Beaches Link and Gore Hill Freeway Connection

Introduction, overview of engagement and submissions received, refinements and clarifications

November 2021

Figure A5-9 Settlement contours – Cammeray, Willoughby (update to Figure 16-8 of the environmental impact statement)

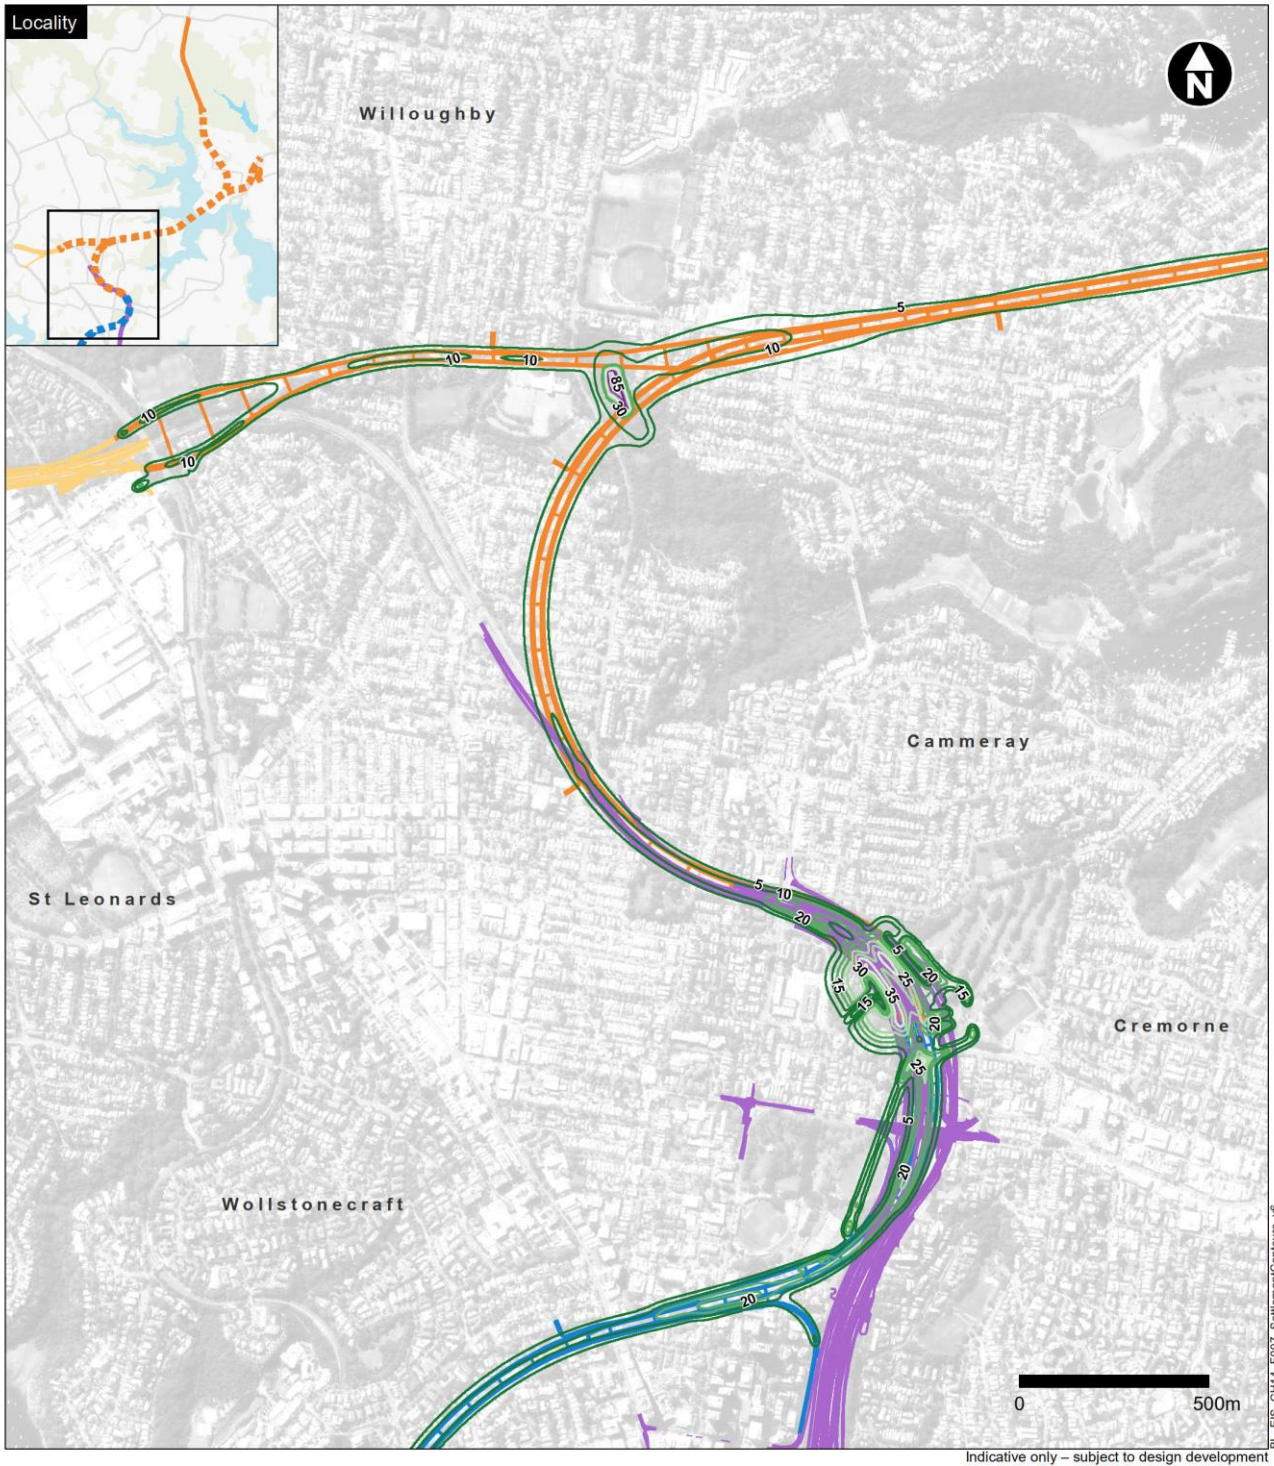
Chapter 16 (Geology, soils and groundwater), Figure 16-8 and Figure 16-9	Inconsistency in figure legend	Figure 16-8 and Figure 16-9 of the environmental impact statement present incorrectly settlement contours in metres within the figure legends. Settlement contours are in millimetres, and the legend should reflect this accordingly. Updates to Figure 16-8 and Figure 16-9 of the environmental impact statement are provided in Figure A5-9 and Figure A5-10 of this submissions report, respectively.
Appendix M (Technical working paper: Contamination), Section 4.3	Clarification	Section 4.3 of Appendix M (Technical working paper: Contamination) states that "only one service station is located near tunnel elements of the project (Cammeray – about 300 metres north of the project)." While Table 4-4 in Appendix M indicates seven service station sites within 500 metres of the project which have been notified under section 60 of the <i>Contaminated Land Management Act 1997</i> , as shown in Figure 4-1, the Cammeray site is the closest to the tunnel – all the rest are closer to surface works elements.
